<u>Mr Bowes' objection to the Environment Agency's Application to vary the</u> <u>Scheme within the River Medway (Flood Relief) Act 1976</u>

Environment Agency technical response, March 2021

Figure 1: Increase in flood depth in a 1.33% flood event. 28.05m AOD vs 28.6m AOD

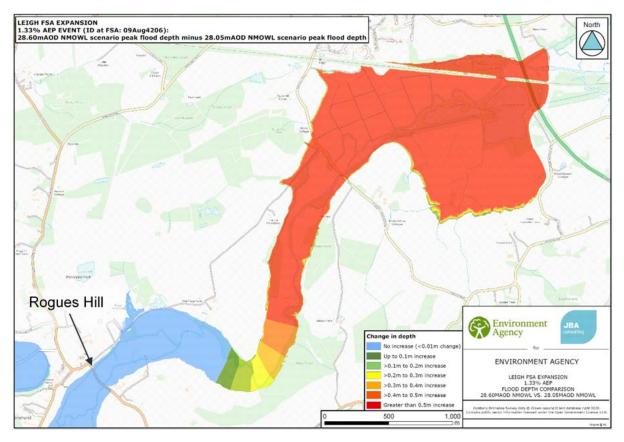
1. Whilst it is recognised that there is a need for adjustment to the flood storage area in order to protect properties downstream we are very concerned that not enough consideration or communication has taken place with communities upstream. Most importantly, no monitoring has taken place, the safety aspects, accessibility of the village or potential effect on the community and property in Penshurst have not been properly assessed and no solutions have been proposed. Highways have not been consulted and the application is made based entirely on theoretical reports rather than real life evidence with no attempt made to verify the theory which has itself changed over time.

11. The modelling is based on a level of 28.395m whilst the proposal is at 28.6m – why? On P21 it is stated that the flood levels will 'not' increase near Penshurst Place as a result of the proposed scheme and then they say on P23 that the flood levels in Penshurst will rise by 0.1m, then the map on P24 shows no increase!

Our modelling indicates that the proposal to increase the maximum impoundment level will not increase the depth of flooding above Rogues Hill. This is demonstrated in the flood risk assessment submitted as part of the planning application for the expansion. The flood risk assessment contains details of the impacts and a range of maps and plans to illustrate the impacts and benefits.

Figure 1 below shows the increase in flooding depth from raising the Leigh FSA maximum impoundment level from 28.05m Above Ordnance Datum (AOD) to 28.6m AOD (measured at the main Leigh FSA embankment) during a 1.33% flood event. For consistency, the map below has been taken from the Flood Risk Assessment which accompanies the planning application. This map has been updated since the submission of the Application. Whilst it shows greater depth variation lower in the FSA, the point at which the effect of the expansion dissipates remains the same.

As noted in Figure 1, depending on the size of the event, the proposed changes will increase the depth of flooding at the Leigh end of the FSA, but this effect dissipates toward the upper end of the FSA (downstream of Rogues Hill).

Figure 1 in our response to your first point shows a plan of the additional depth of water during a modelled 1.33% (1 in 75 year) flood event as a result of changing the maximum stored water level from 28.05m AOD to 28.6m AOD.

We chose this scenario to demonstrate the impact of expanding the FSA because it shows the greatest change in flood depths as a result of the proposed change. The depth increase for the majority of the storage area will be greatest for the 1.33% event.

During more extreme flood events, such as a 1% (1 in 100 year) plus climate change event, the increase in depth as a result of the proposed change reduces. This is because the natural flood level, which is greater, dominates.

The statement on page 24 of the Application is referring to the impact of the <u>existing</u> flood storage area at 28.05m AOD, which can be up to 0.1m for a large flood event if the storage area is used to near capacity. There is no additional increase in flood depth at Penshurst if the maximum storage level is increased to 28.6m AOD.
